City of Mississauga

City Department and Agency Comments

Date Finalized: 2025-08-21	File(s): A260.25
To: Committee of Adjustment	
From: Committee of Adjustment Coordinator	Meeting date:8/28/2025 1:00:00 PM

Property Address: 1155 Birchview Dr, Unit 2

Appendix 1 – Transportation and Works Comments

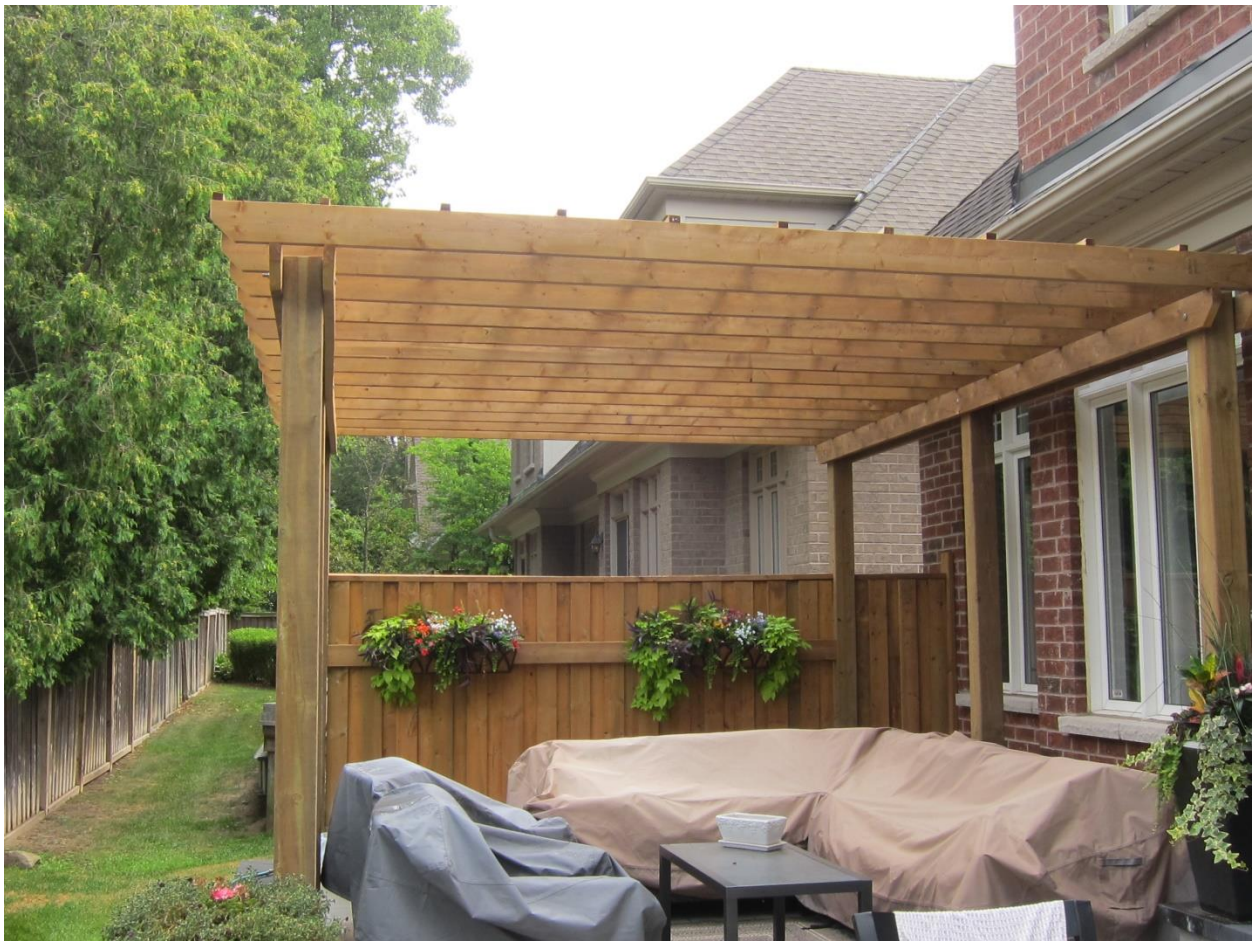
Enclosed are pictures of the structure in the rear yard. We have no drainage related concerns.
